TRANS/WP.29/GRSP/23
31 August 1998

Working Party on Passive Safety (GRSP)

REPORT OF THE MEETING OF EXPERTS ON PASSIVE SAFETY
ON ITS TWENTY-THIRD SESSION

(4 - 8 May 1998)

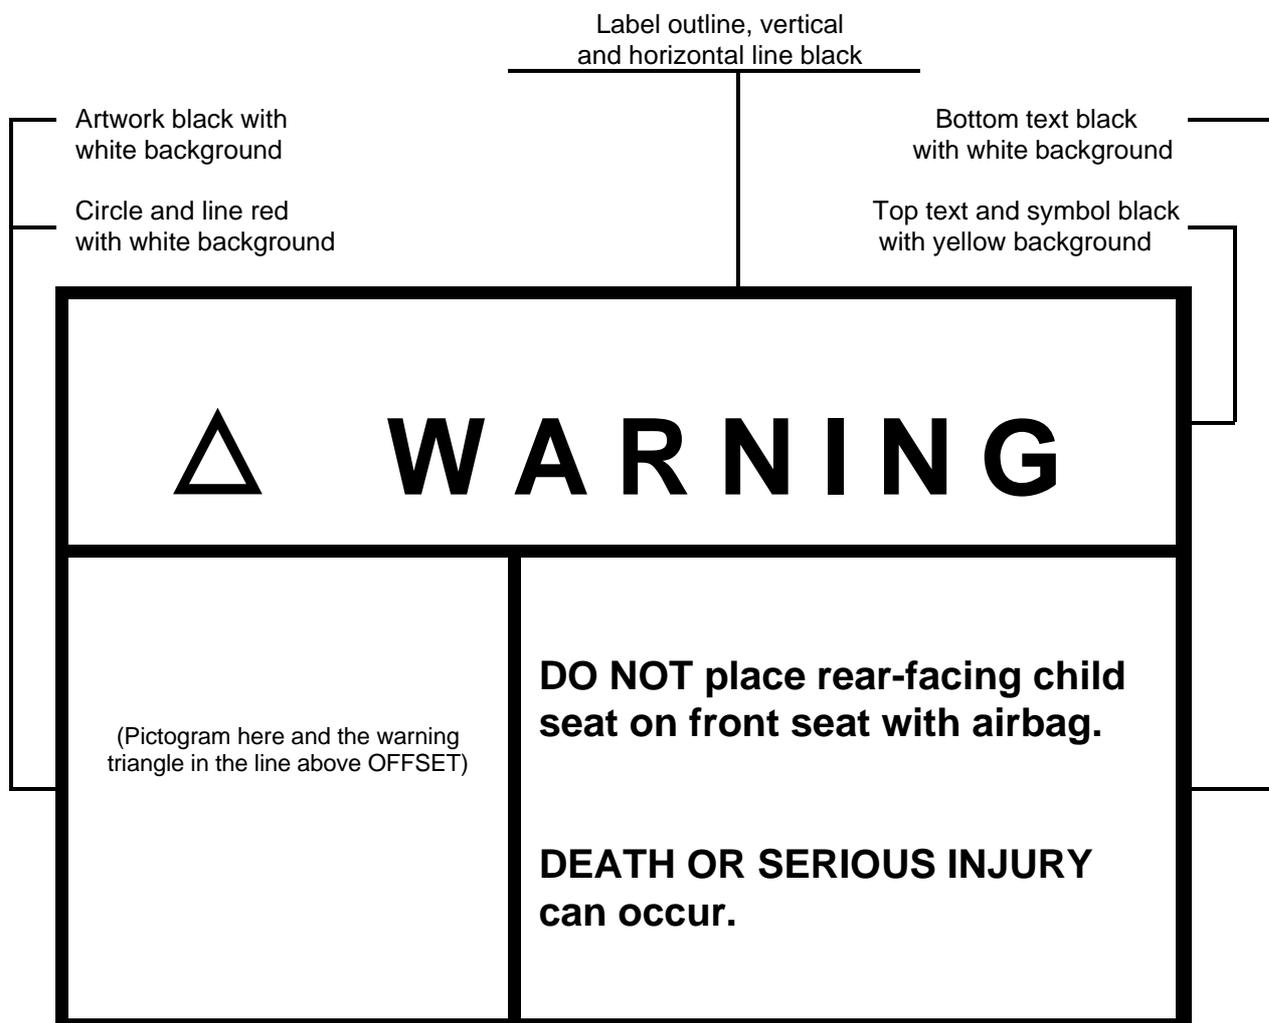
Paragraph 4.5., amend to read:

"4.5. In addition, in the immediate area where the child's head rests within the child restraint and on the visible surface of the child restraint system, rearward-facing restraints shall have the following label permanently attached (the text information shown is a minimum).

This label shall be provided in the language(s) of the country where the device is sold.

Label minimum size: 60 x 120 mm
